June 22, 2020

**Re: Response to Review Comments & Final Amended Subdivision Application
Veery Estates Condominium – Major Subdivision Plan Application
RMills, LLC - Applicant**

Final Plan - Major Subdivision

Project Name: VEERY ESTATES CONDOMINIUM

Routing Diagram for 17057-Post

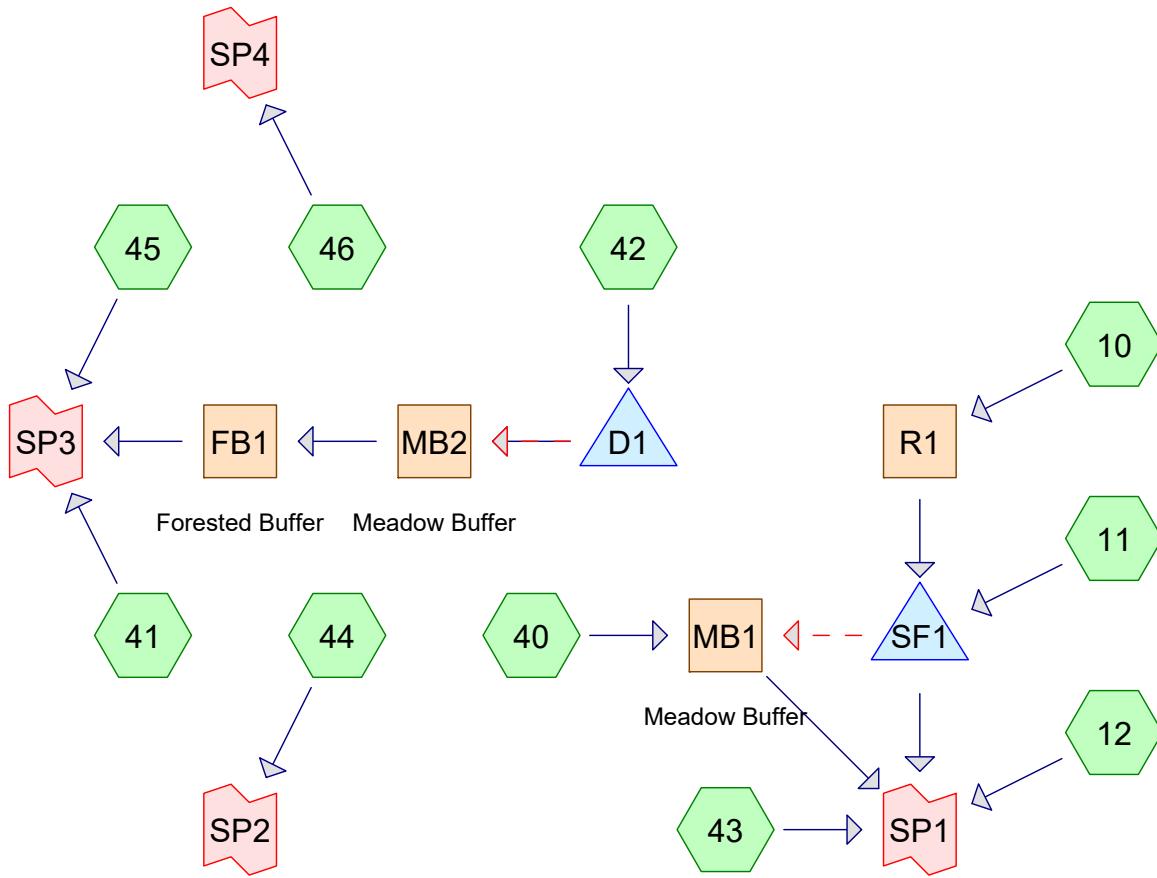
Comment 3: The hydrocad analysis includes a "Pond D1". Please clarify on the Post-Development Stormwater Map where the pond is.

Comment 4: The stormwater treatment table on the PDSM indicates WS-40 is treated by FB-1 and MB-2, but the routing diagram does not show the flow path through these buffers. Please clarify.

Response 3: The center of the cul-de-sac has been modeled as Pond D1. A symbol has been added to the Post-Development Stormwater Map.

Response 4: The table states that WS-40 is treated by Buffer 1 – MB1 which is accurate.
